Released under the Creative Commons Attribution Share-Alike 3.0 License http://creativecommons.org/licenses/by-sa/3.0			0 0		
TITLE: H20hNo		SFI	Ξ	SFE	
Design by: N. Seidle			R	EU:	
Date: 10/20/2013 4:48:15 PM	Sheet: 1/1		L

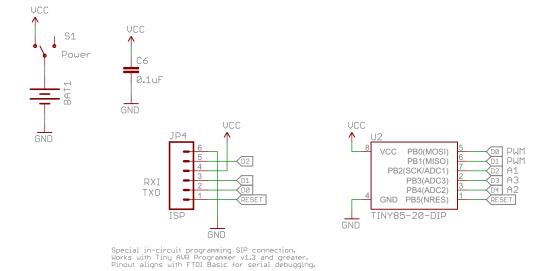
Changes to v1.2: Corrected FP for CR2032 holder Removed 10k pull up on RES
